PLANNING COMMISSION STAFF REPORT

HEARING DATE: April 5, 2018

Kiewit Infrastructure West Co. – Kramer Junction Borrow Pit

**MINE RECLAMATION PLAN
FOR THE
KRAMER JUNCTION BORROW PIT**

RECLAMATION PLAN - KRAMER JUNCTION PIT

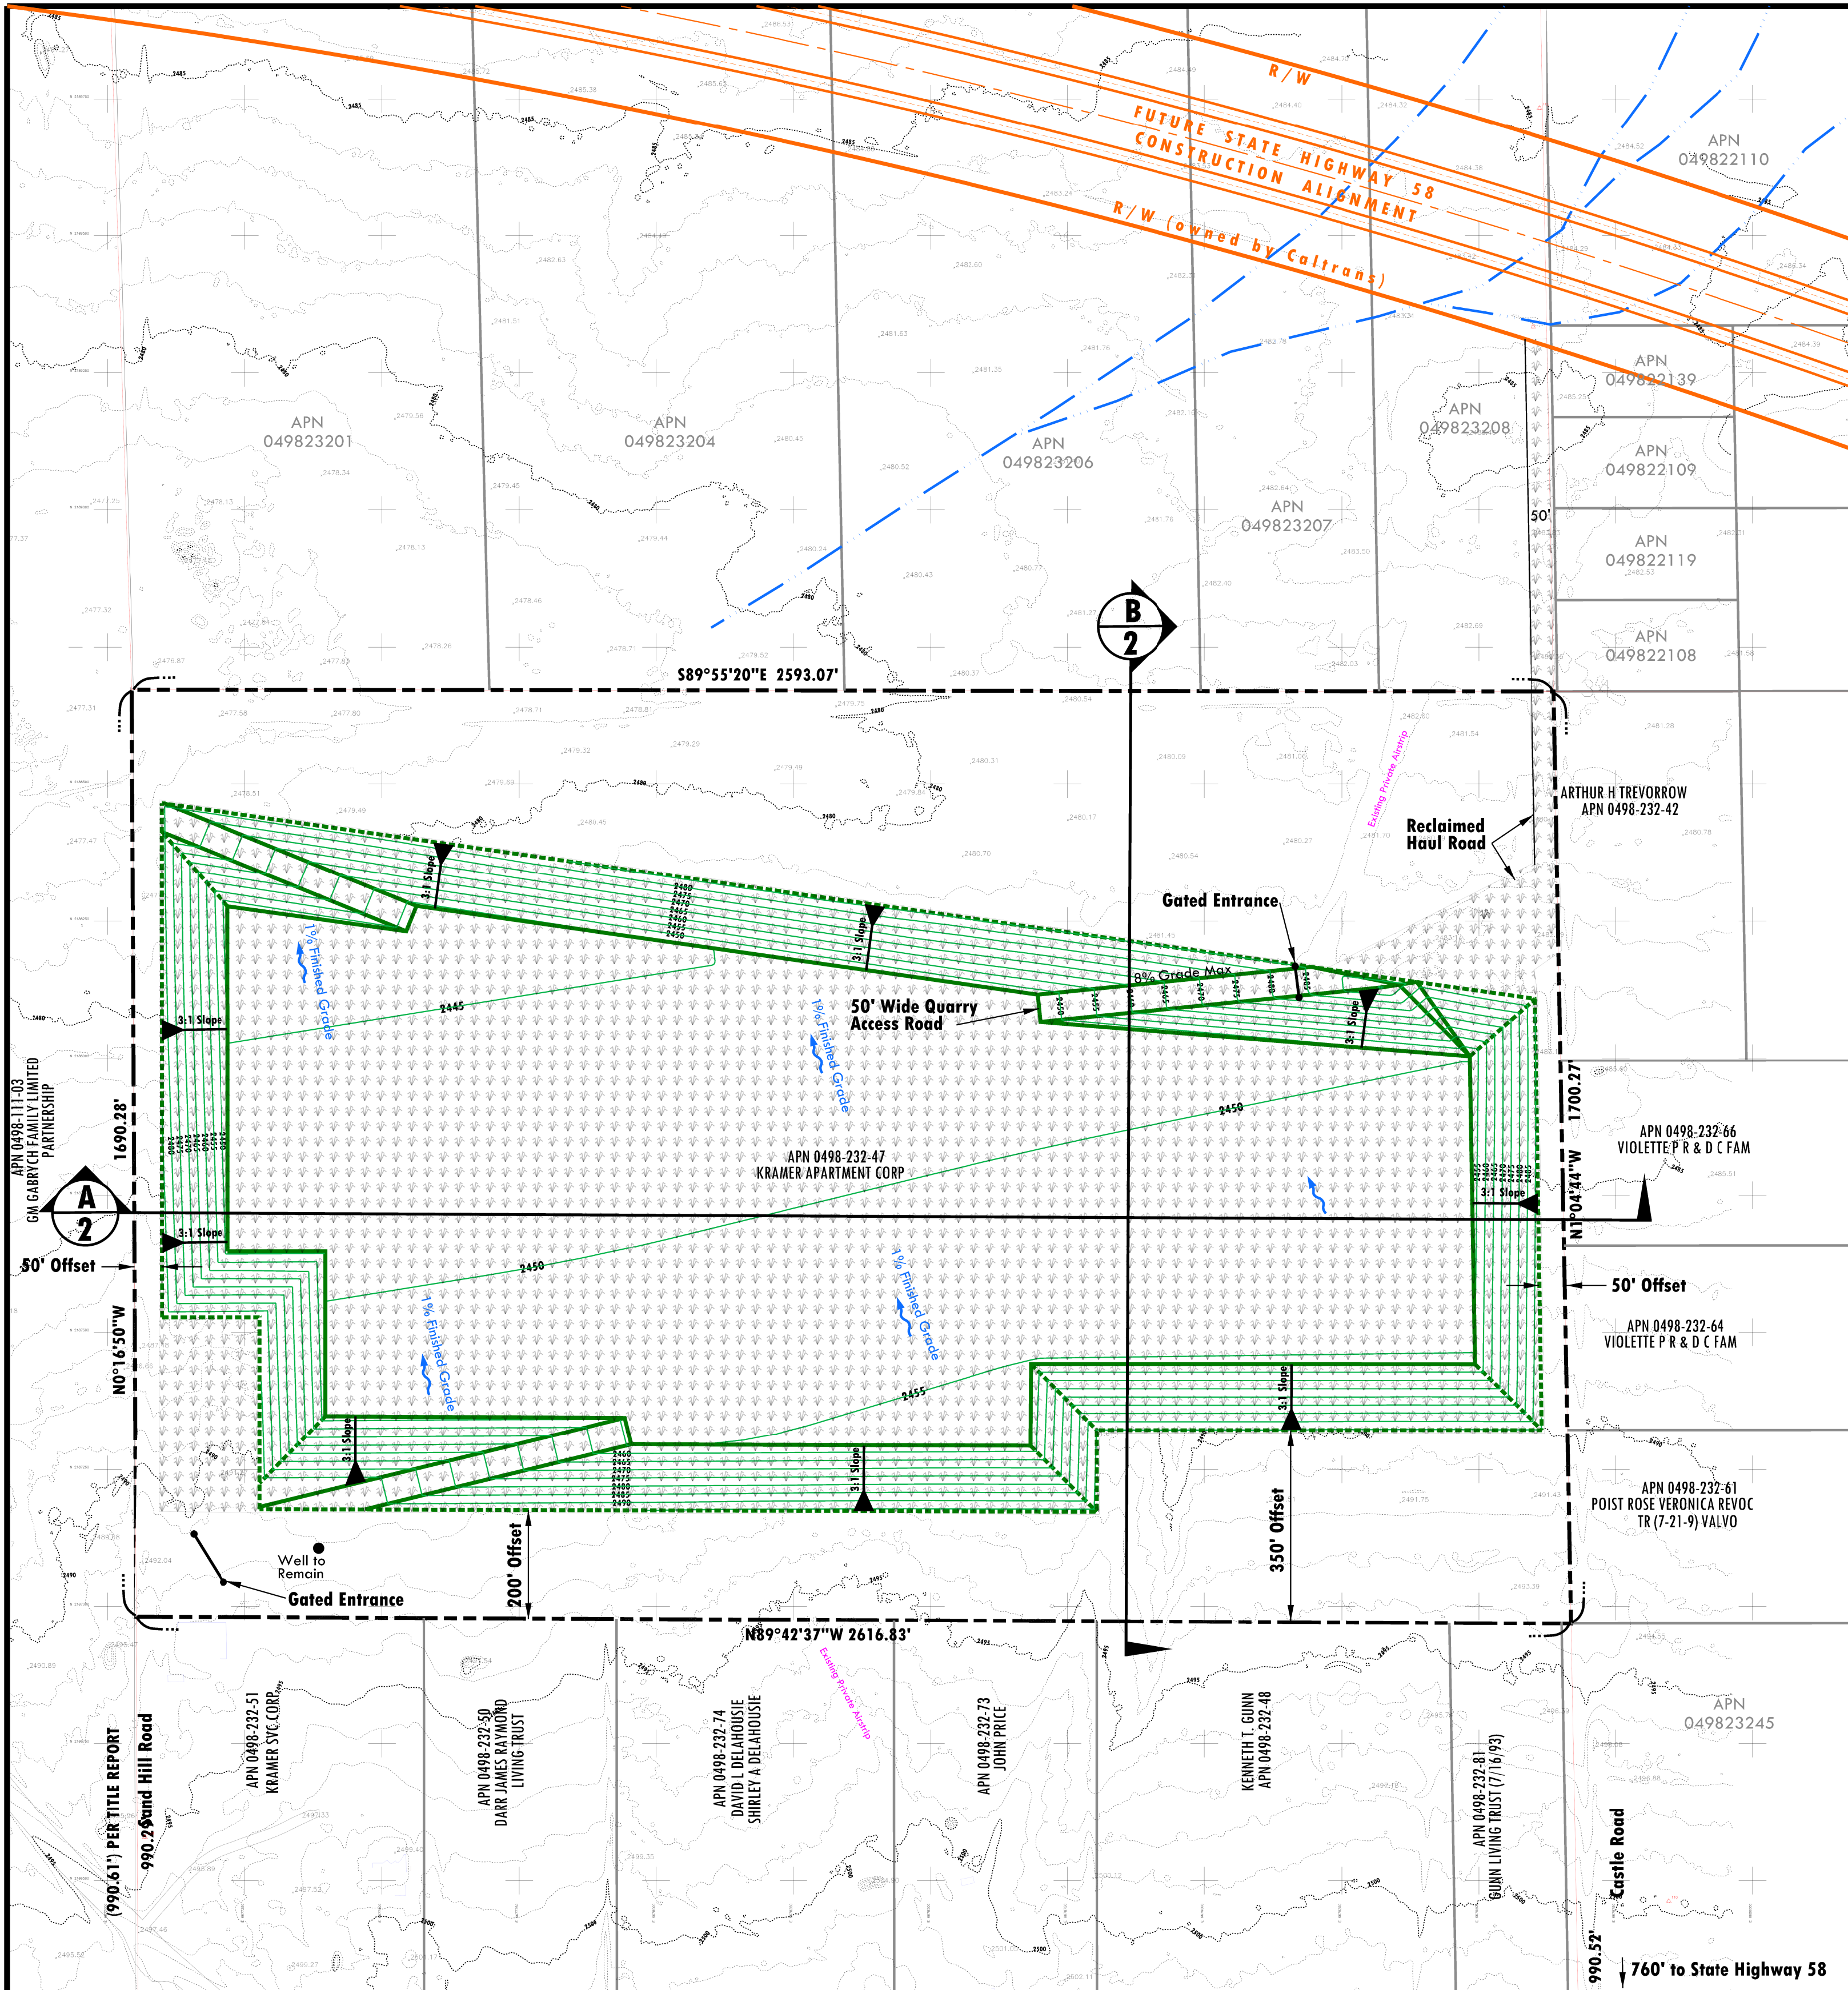
Seeding methods and rates are discussed on page 7 of the revegetation plan and page 20 in the reclamation plan, with the recommended seed mix in Table 3. However, a different seed mix is listed on map sheet 2. DMR recommends that the seed mix on the map sheet be replaced with the one in Table 3 as it is more site-specific. Desert mallow (*Sphaeralcea ambigua*) was observed during the site visit and DMR recommends adding this species to the seed mix.

“A different seed mix is shown on map sheet 2 [Reclamation Plan map] [than is shown in the Mine Reclamation Plan and the Revegetation Plan for Table 3.]”

Source: S&S Seeds, Jericho Systems, DMR - October 2017; revised February 2018 (typical depending on seed availability)
